APPLICATION NO:
F/2000/0569

LOCATION:
50 Loddon Bridge Road, Woodley Reading.

PROPOSAL:
Proposed first floor side and rear extensions t dwelling plus side dormer extension

Notification of Approval of Permission

Block Plan 1:500

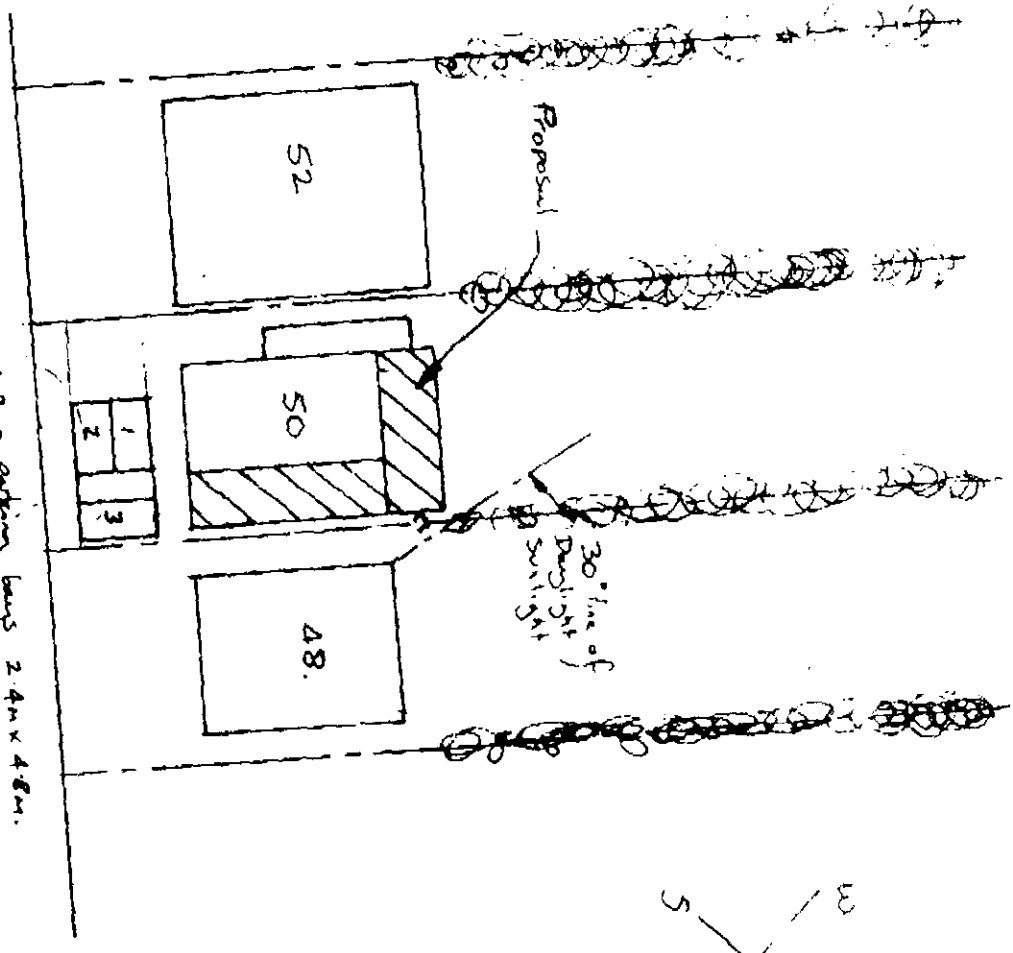
ii. The 1:500 block plan still has the compass nearly 180 degrees out as previously noted. ✓

ii. The 1:500 block plan still has the compass nearly 180 degrees out. This may have significance on your consideration as much of the light to my property comes from the rear. When I was speaking to my neighbour the other day, he informed me that you may request that the 2 storey extension to the rear of no. 50 is "stepped in" a few feet away from my property to allow more light. I would appreciate it if this recommendation is upheld.

SIDE ELEVATION 1:100

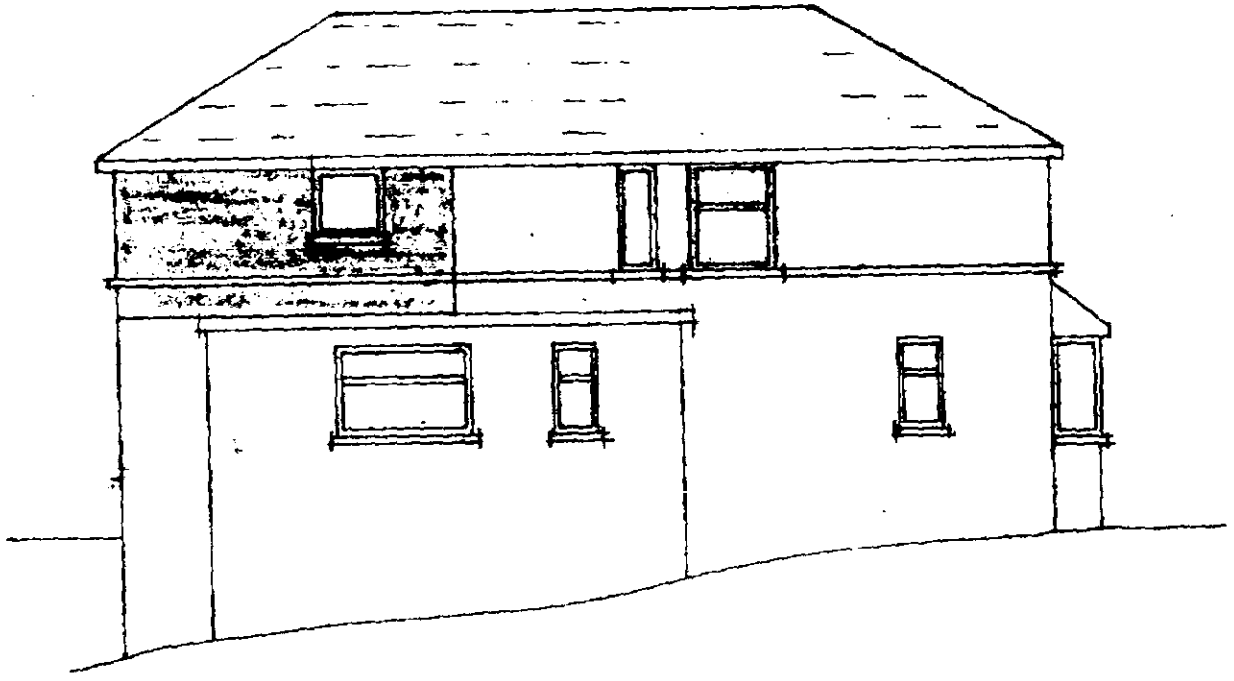
The new plans show the following: Side elevation, adjacent to 52 Loddon Bridge Road, showing the existing window to be retained and a revised parking layout with the front garden shown the correct depth.

iii. The side elevation does not show an "obscured" window that is referred to in writing on the plan. I am not sure whether the revised plans include this window or not. – agree, condition not to insert.

iii. The side elevation no longer shows an "obscured" window, although this is still referred to in writing on the plan. As my earlier letter stated:

Condition
6. This permission relates to the application as amended by and shall be carried out in accordance with revised drawing nos MC/921/02A and MC/921/01A submitted to the Local Planning Authority on 12/06/00 showing the rear of the first floor side extension flush with the rear elevation of the original house and set back at the front and the drawings received on 28th June 2000 showing the revised parking layout and retention of the existing window in the north-east elevation.
